# GLASTAR SERVICE BULLETIN 9

**Subject:** Rod-End Bearings (Part Number 170-0110-003)

**Applicability:** 170-0110-003 rod-end bearings shipped to GlaStar builders before 6/30/96 (through serial number 5275)

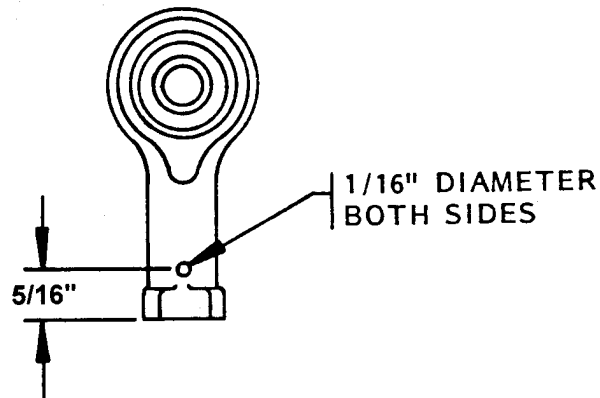
**Discussion:** The affected rod-end bearing, which is used in both the manual and the electric trim system for the GlaStar, may lack the two small inspection holes that are necessary to determine if the rod-end is threaded a sufficient distance onto its actuator rod.

Any rod-end bearing without inspection holes must be modified to permit verification of adequate threading onto the control actuator rod. Using a **1/16"** bit, drill holes through both sides of the rod end bearing **5/16"** from the threaded end of the bearing, as shown.
